SB0028

ESG SERVICE BULLETINAffected Equipment: OptiView Panel Retrofits
HT/OT & Competitive Chillers**Subject: Recall of Retrofit Temperature Sensors 025-37825-004 & 025-37825-001
From Batches Manufactured 07/18/02 & Shipped 07/18/02 Thru 01/20/03****Issue Date: 01/28/03****Withdrawal Date: 02/28/03****Data Control Level: B****Materials Needed: Replacement Sensor 025-37825-004 and/or 025-37825-001****Tools Required: Combination Wrench (7/8"), Hand Tools and Pipe Thread Sealant****Estimated Time Required: 2 Hours for Sensors installed in Chillers****Warranty: Yes: Parts - Baltimore Parts Center. Labor: Service Aftermarket Warranty****Revision Notes: N/A****BACKGROUND**

025-37825-004 & 025-3785-001 Sensors Manufactured Jul 18, 2002 Failing Open Circuit

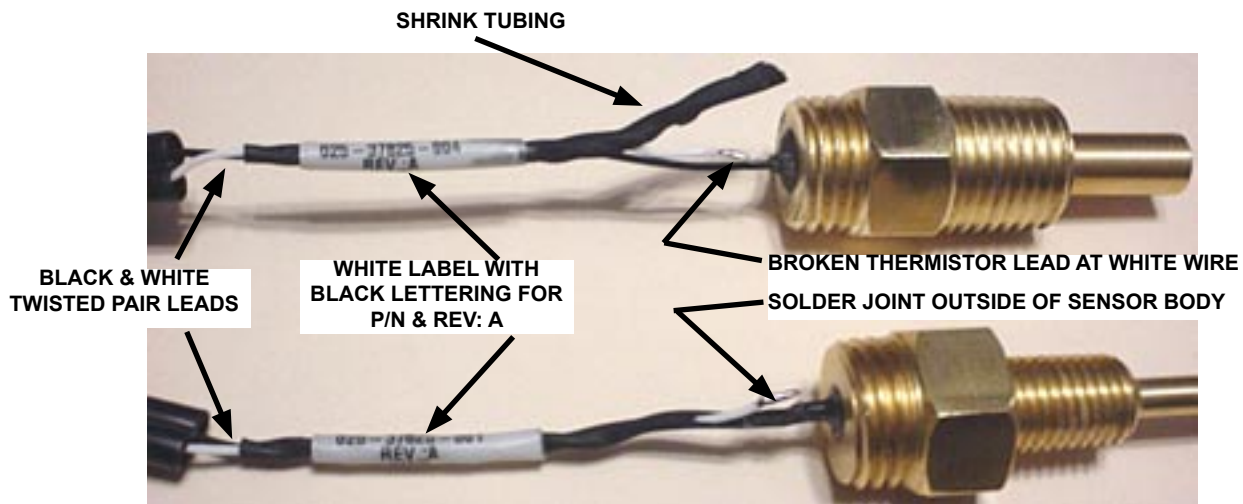
The Sensors thermistor-to-wire solder joints are supposed to be a minimum of ¼ " within the epoxied area of the sensor brass body. The affected sensors were mis-manufactured with the thermistor to white wire solder joint being made external to the epoxied area at the surface of the sensor body where normal bending of the lead wires is breaking the thermistor wire causing an open circuit failure of the sensor.

The recalled sensors are shown below with twisted pair black/white lead wires covered with black shrink tubing cut back to expose the broken thermistor lead at the solder joint to the White wire. The thermistor-to-wire solder joints are supposed to be a minimum of ¼ inch within the epoxied area of the sensor brass body.

When you have identified the number of the recalled Sensors that require replacements contact the Baltimore Parts Distribution Center (B-PDC) and request replacement sensors per B-PDC Warranty Return Authorization (WRA) procedures.
